06V-198 Supplement

Subject: Notification of Recall Pursuant to 49 CFR Part 573 (2006)

Model Years 1998 - 2000 Audi A6, A6 Avant, S6, and S6 Avant,

Cover for Crossmember

# A6 Dashboard - Recall Repair Solution

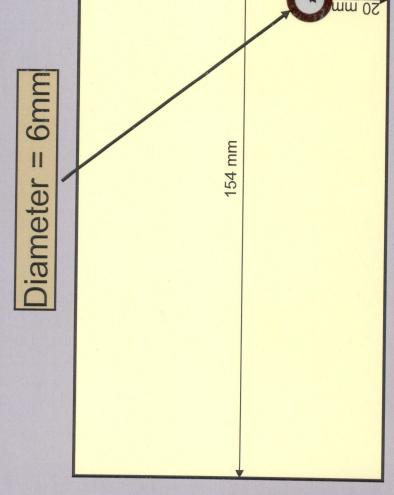
An additional cover will be installed over the crossmember to protect against the headlight switch wiring harness rubbing against the crossmember. This cover includes a positive retention wire and can only be installed when the lower dash trim panel is removed. (See the attached drawings for additional details)
